Rampion 2 Wind Farm

Applicant's Comments to Deadline 5 Submissions

Date: August 2024
Revision A

Screenshot from Inset 45 of the updated Arboricultural Impact Assessment submitted at Deadline 4 [REP4-037] indicating a section of W67 (trees not surveyed in detail) indicated in the key as 'trees to be removed' (indicated in red)

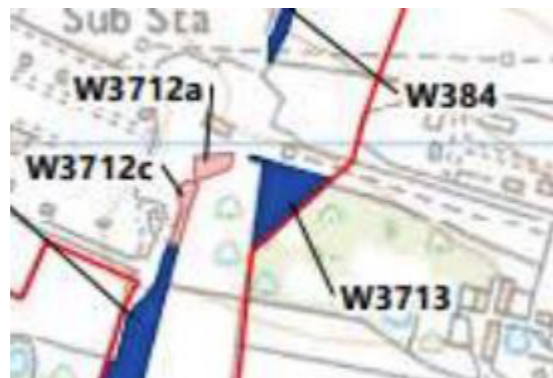
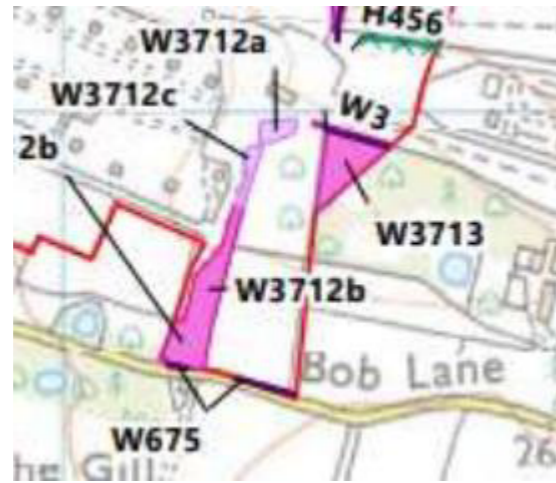
CC remains unsatisfied that the impact on deciduous woodland, a priority habitat, are at all clear at this location."

Figure 1 Predicted Worst Case Unmitigated and Mitigated (DBBC) Behavioural Response Impact Ranges for Sensitive Features from the Piling of Monopile Foundations (141dB SELss)

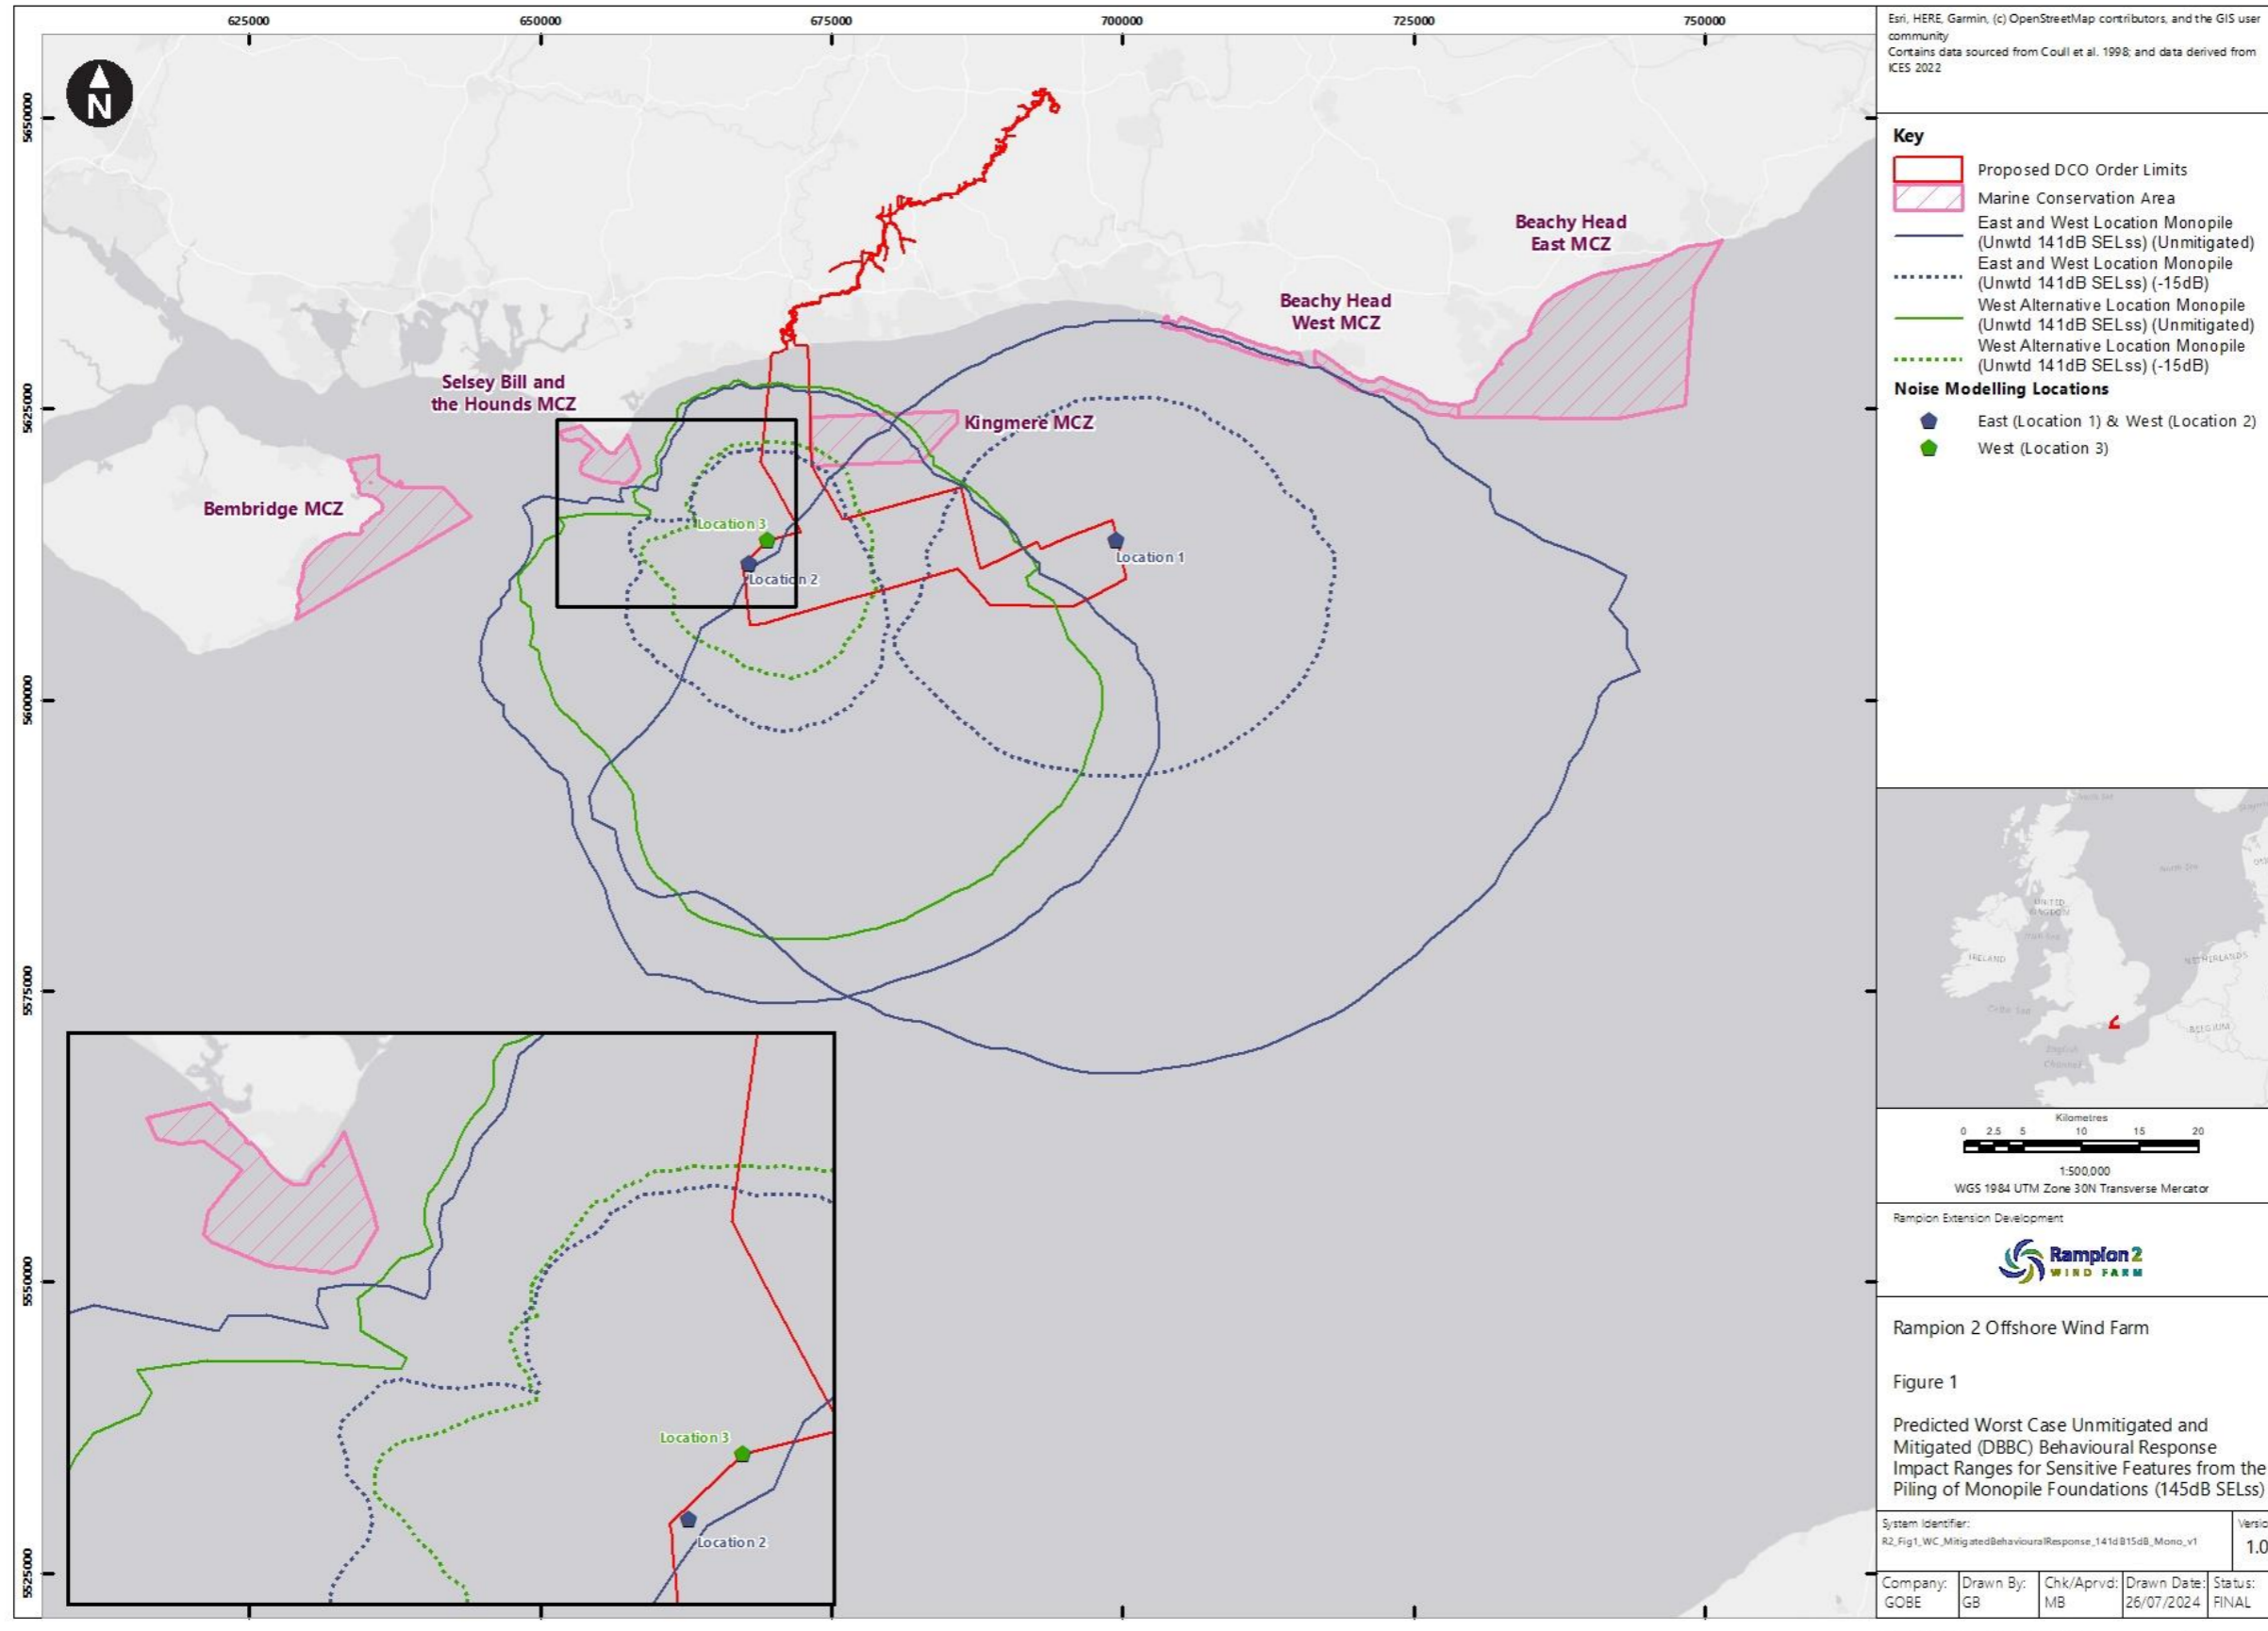
In a meeting held on 28 June 2024, Natural England queried the worst-case underwater noise modelling location on the western boundary (Location 2 on **Figure 1** to **Figure 4**) of the Rampion 2 array area, with regard to the Selsey Bill and the Hounds MCZ. This was also raised at Deadline 5, reference Q3a-1 of Appendix N5 to the **Natural England Deadline 5 Submission – Natural England's Response to the outstanding questions from The Examining Authority's request for further information from Natural England arising out of Issue Specific Hearing 2 [PD-011] and The Examining Authority's Further Written Questions and requests for information [PD-012] [REP5-141]**, and references 2.1.4, 2.1.6 and 2.1.22 of Appendix E5 to the **Natural England Deadline 5 Submission – Natural England's Advice on Fish and Shellfish [REP5-139]**. To provide reassurance to Natural England, this document sets out the mitigated and unmitigated underwater noise impact contours relative to the Selsey Bill and the Hounds MCZ from the location closest to the MCZ on the western boundary of the Rampion 2 proposed DCO Order Limits.

The Applicant confirms that, as evidenced by the additional underwater noise modelling, the outputs of which are presented in **Figure 1** to **Figure 6**, the worst case modelling location has been used for the assessment of underwater noise impacts on seahorse as features of the Selsey Bill and the Hounds MCZ.

The Applicant confirms that the piling location on the western boundary (Location 2 on **Figure 1** to **Figure 6**) of the proposed DCO Order Limits was identified as the worst-case location on account of the bathymetry of the site (the modelled location lies in an area of deeper water). Any location inshore of this modelling location, lies in shallower water depths, where underwater noise propagation and therefore the range of impact is reduced.

The mitigated underwater noise impact range contours (from the implementation of DBBC) from the closest location on the western boundary (Location 3) to the Selsey Bill and the Hounds MCZ, as defined using the 141dB SELss disturbance threshold (based on a study by Kastelein *et al.* (2017)) are presented in **Figure 1** and **Figure 2** relative to the MCZs of which seahorse are a qualifying feature. As evident, piling at a location in closer proximity to the MCZ (Location 3), does not represent the worst-case scenario for underwater noise. Furthermore, the use of DBBC at this location will also mitigate the behavioural impact underwater noise contours away from the MCZs designated for seahorse. The Applicant therefore confirms that the underwater noise modelling undertaken, and presented in **Figure 1** and **Figure 2** demonstrates that the Applicant has used the worst case modelling location for the assessment of underwater noise impacts on seahorse as features of the Selsey Bill and the Hounds MCZ. The Applicant is therefore confident that piling at Location 3 will not result in any impacts from underwater noise in exceedance of those assessed in the ES, based on modelling from Location 2.
